SERVICE BULLETIN

B-001

SAFETY RECALL CODE 0800 - FRONT BRAKE LINE

Figure 2. Front Fender

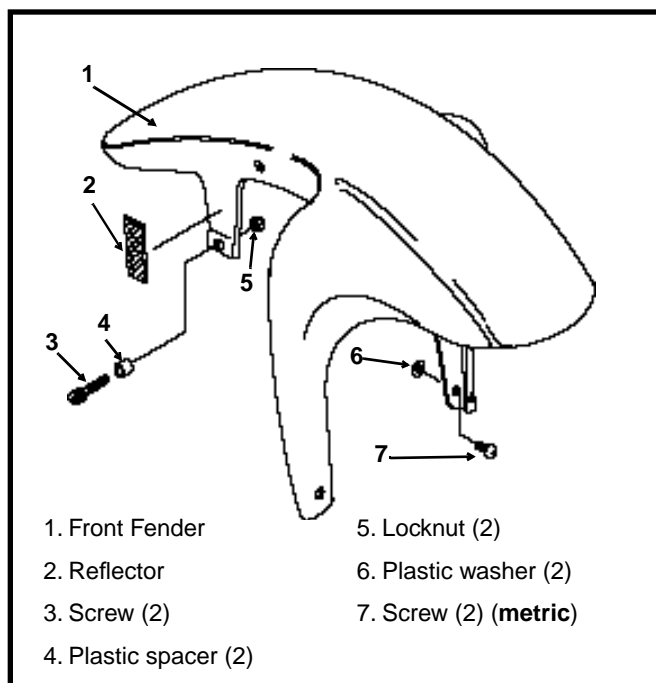
Routine testing has revealed the possibility of a crack developing in the front brake line. This could result in fluid leakage and subsequent loss of braking ability.

2. See Figure 1. Remove screw (4) to detach brake line clamp (5) from front fork lower bracket (right side).
3. See Figure 2. Remove front fender attachment screws (7) metric and plastic washers (6). Remove front fender attachment screws (3), spacers (4) and locknuts (5).

4. Raise fender to remove screw (6), clamp (7), plastic flat washer (8), and nut (9) to detach brake line from fender.
5. Remove banjo bolt (1) and master cylinder gaskets (2) to detach brake line from master cylinder body. Discard gaskets.

9. Orient clamp. Tighten nut (9), plastic flat washer (8), clamp (7) and screw (6) to attach brake line to fender.
10. Secure front fender using screws, washers and locknuts removed in step 3. Tighten all hardware to 8-13 ft-lbs (12-18 Nm) torque.

Figure 1. Front Brake Line

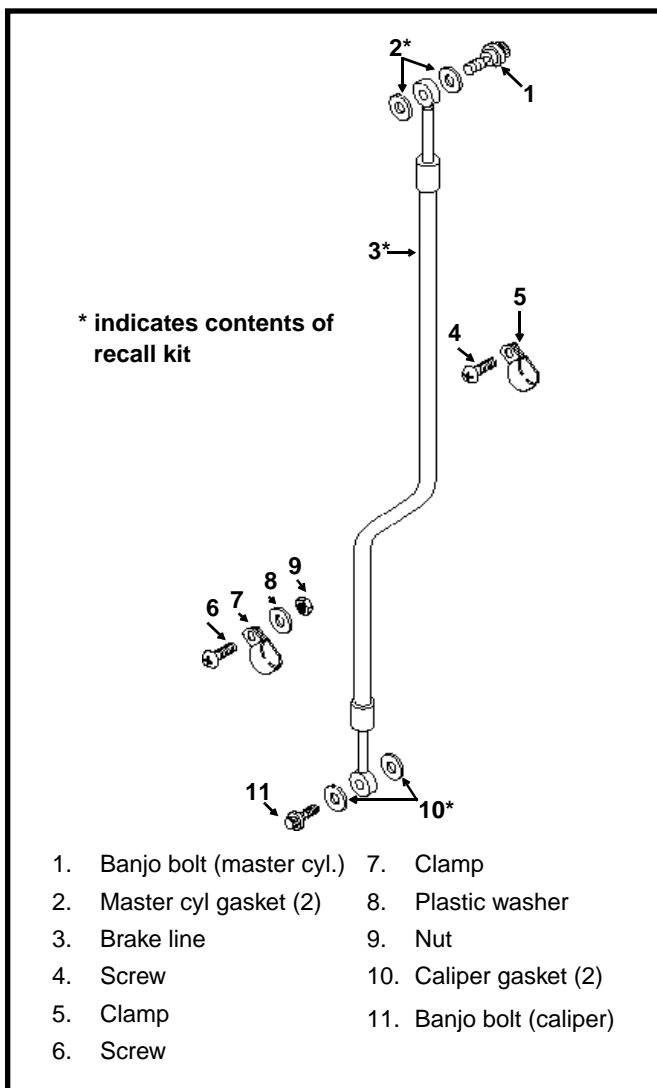
As a precautionary measure, Buell Motorcycle Company elected to initiate a voluntary recall in the interest of motor vehicle safety. The condition will be remedied by replacing the front brake line on all potentially affected vehicles.

New brake line can be identified by a blue stripe at the end of the caliper fitting.

8. From the master cylinder, the brake line runs downward in front of the right handlebar, where it turns inboard at the front fork upper bracket. Loosely install clamp (5), and screw (4) to attach front brake line to right side of front fork lower bracket.

12. Tighten clamp screw (4) at bottom of front fork lower bracket to 30 **in-lbs** (3.4 Nm) torque.
13. Tighten banjo bolt (1) into master cylinder to 17-22 ft-lbs (23-30 Nm) torque.
